SUBJ: **Addendum 1 – Clarifications to the Specifications and Responses to Vendor's Questions**

BID ITEM: **Bid Item #23-150 Construction - Airfield Electrical System Upgrade for Runways 5-23 & 11-29 for Augusta, GA – Daniel Field Airport**

ADDENDUM NO. 1

C2
sheet 2 of 52

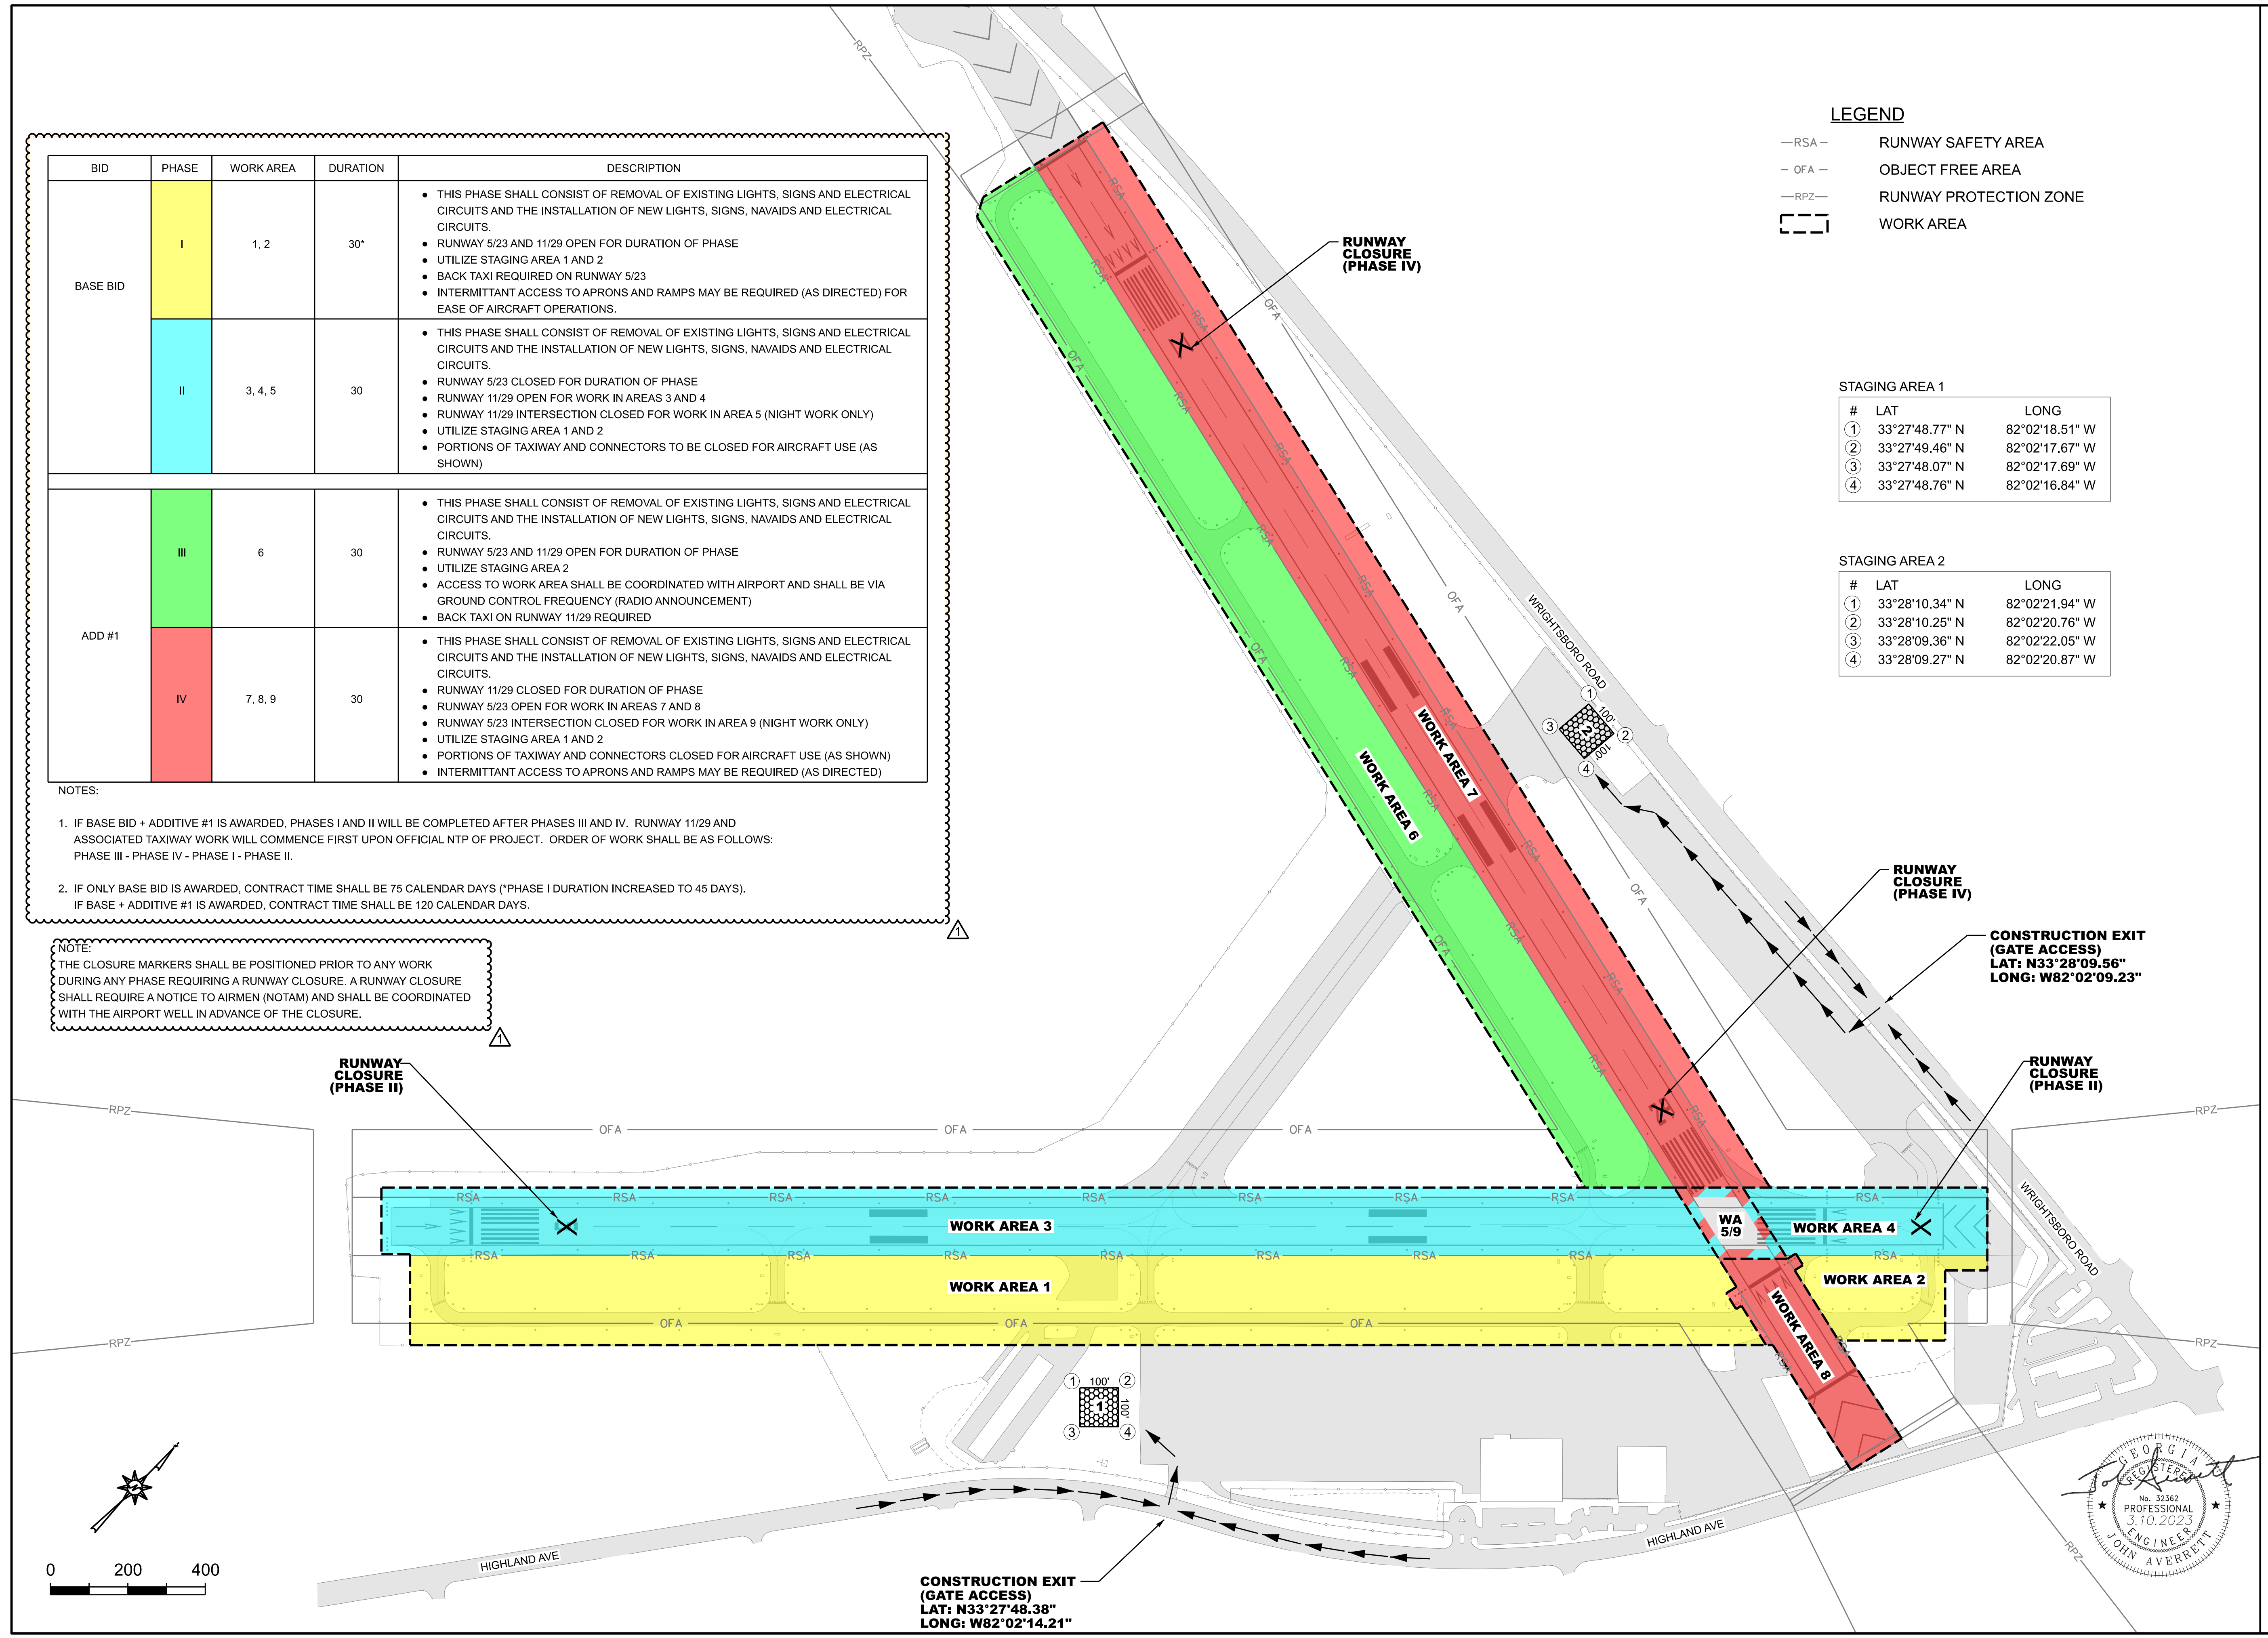
- A. **Replace Title Sheet** with revised Title Sheet attached to this Addendum 1.
- Added note for materials.
 - PID Number added.
- B. **Replace Sheets C2 thru C7** – Project Layout and Construction Safety Phasing Plans with revised Sheets C2 thru C7 attached to this Addendum 1.

- Modifications to all Project Phasing (with durations) and contract time
 - Added notes for R/W closure and low-profile barricade detail.
- C. **Replace Sheet C9** – Construction Safety Notes and Details with revised Sheet C9 attached to this Addendum 1.

AUGUSTA, GEORGIA
 GDOT PID : T007935
 GMC NUMBER : TAUG220004
 SCALE: 1" = 250'

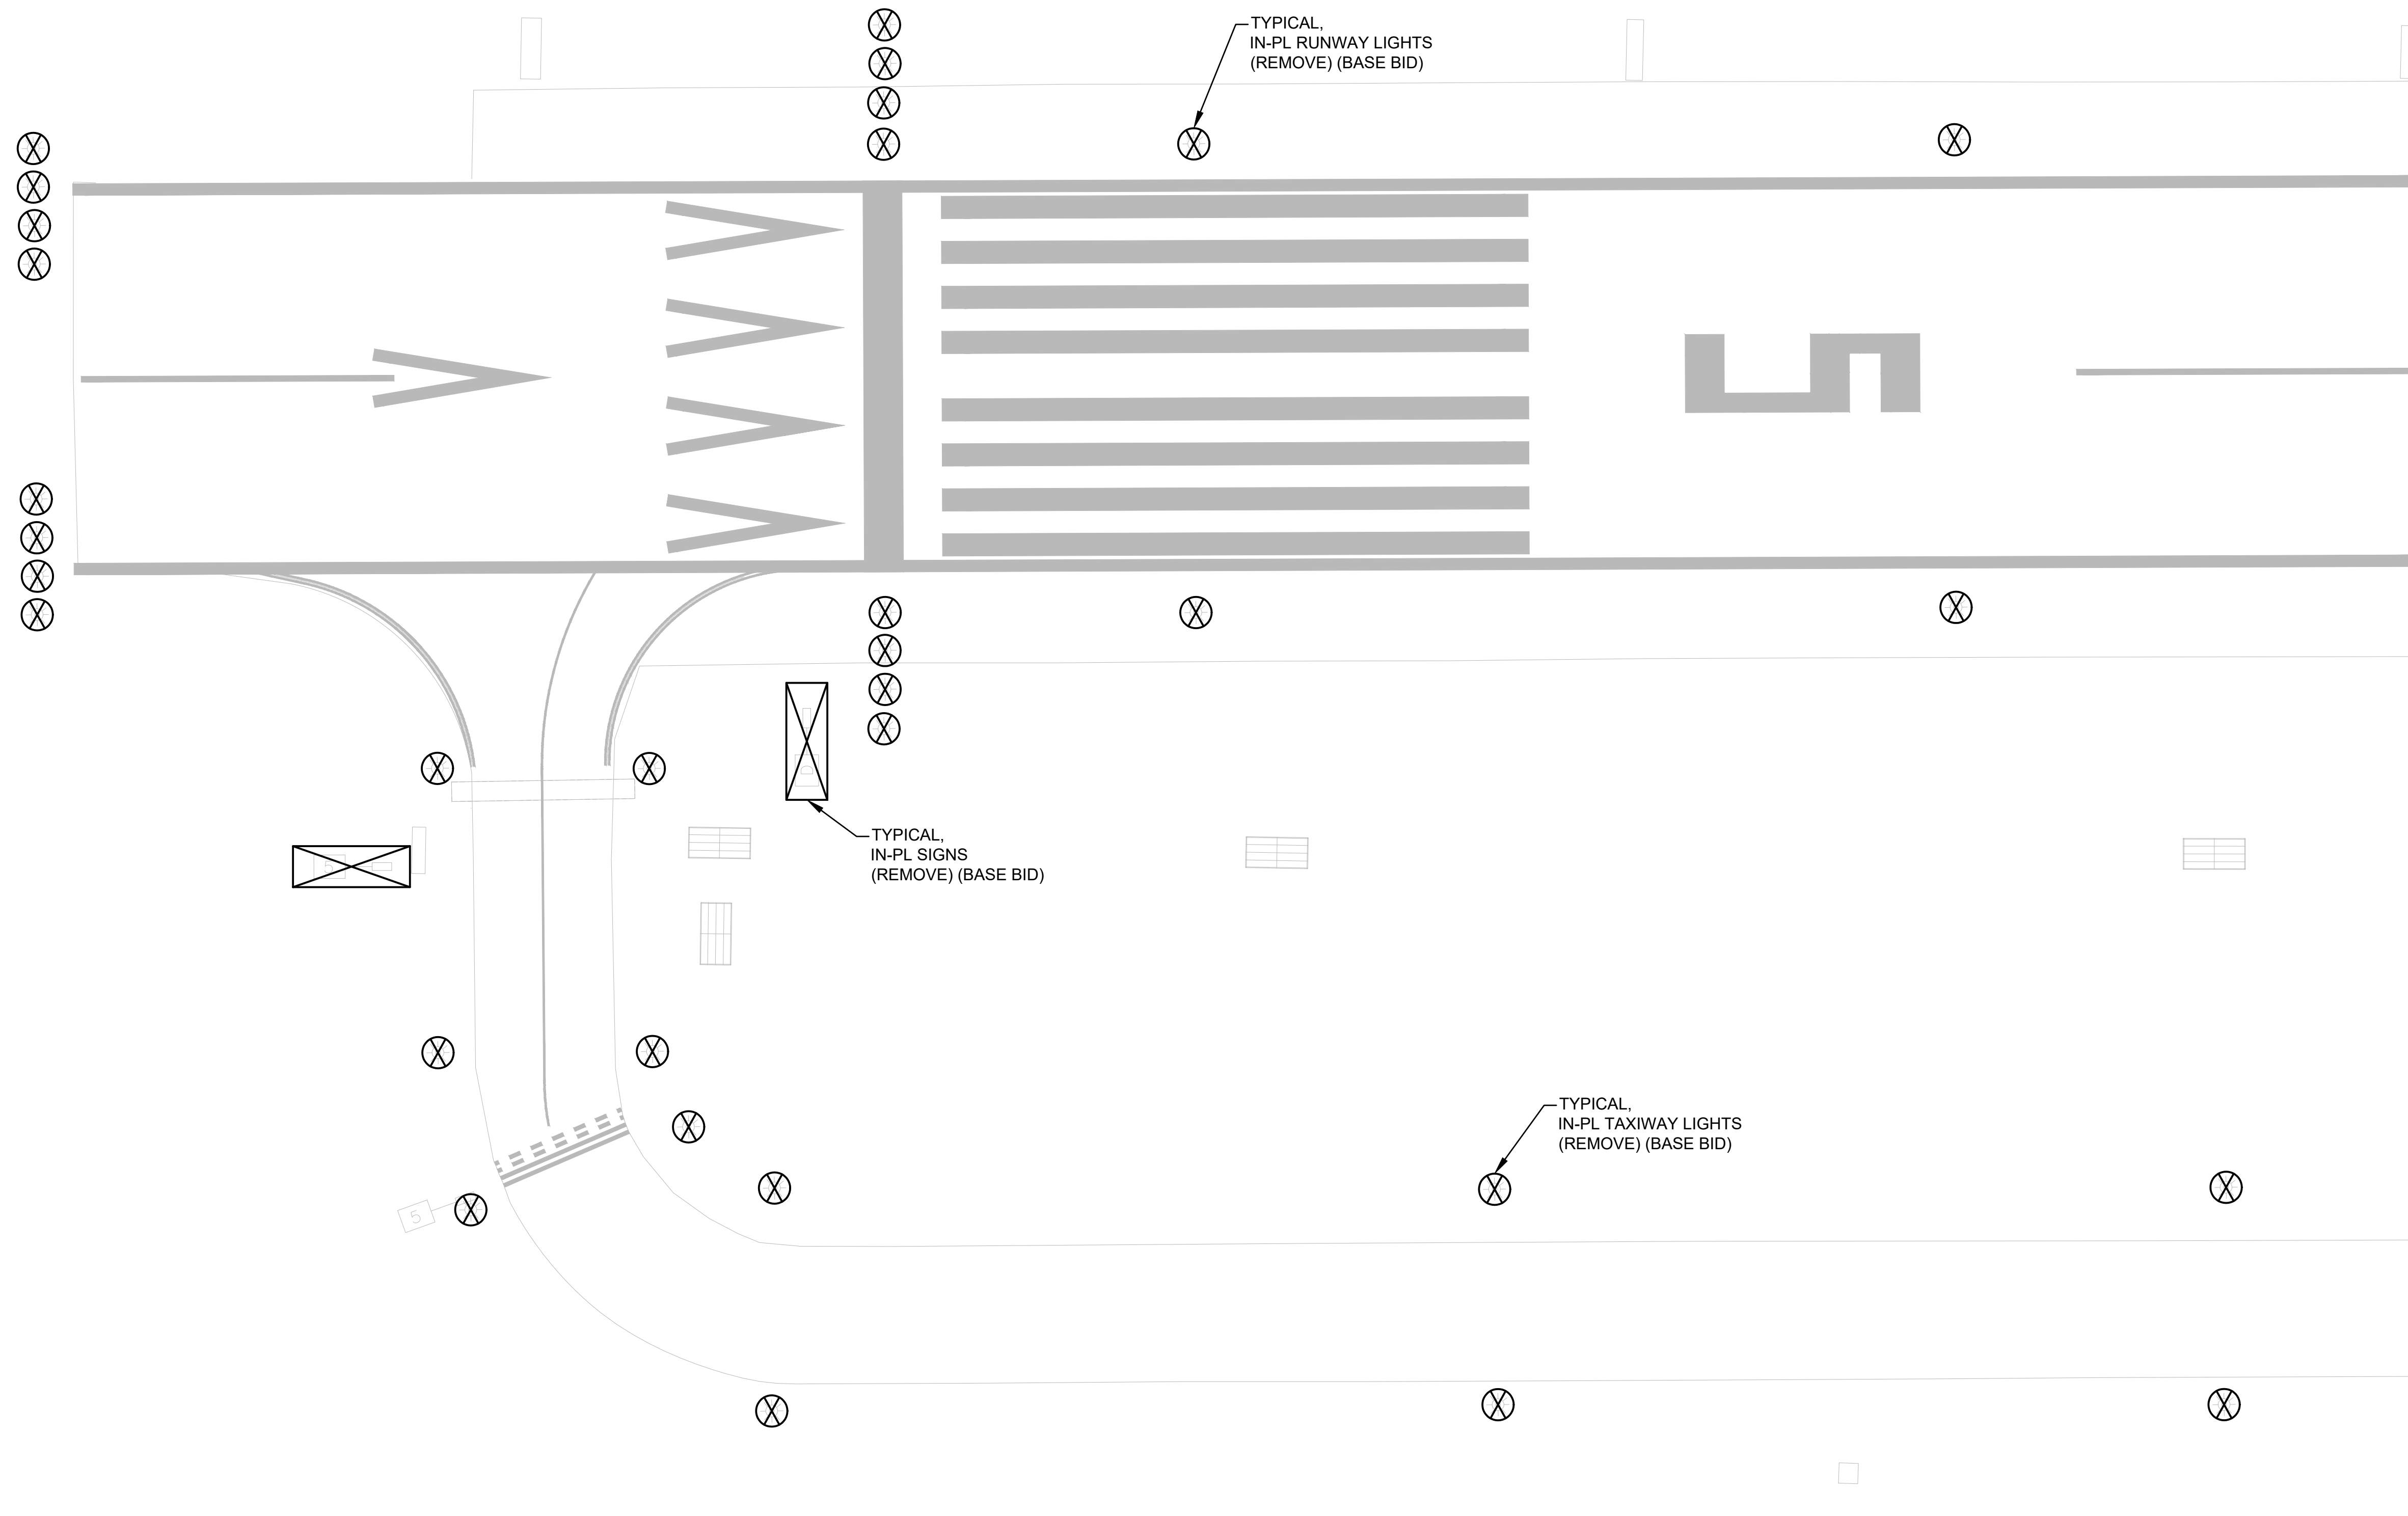
- ALT (Alternate) abbreviation revised to ADD (Additive Bid).
- F. **Replace Sheet E0** – Overall Electrical Reference Plan with revised Sheet E0 attached to this Addendum 1.

- Scale of this sheet revised from 1"-500' to 1"-250'.
- G. **Replace Sheets ED1 - ED4; ED7** – Airfield Lighting Demolition Plan – Runway 5/23 – Part 1-4; Part 7 with revised Sheets ED1 - ED4; ED7 attached to this Addendum 1.
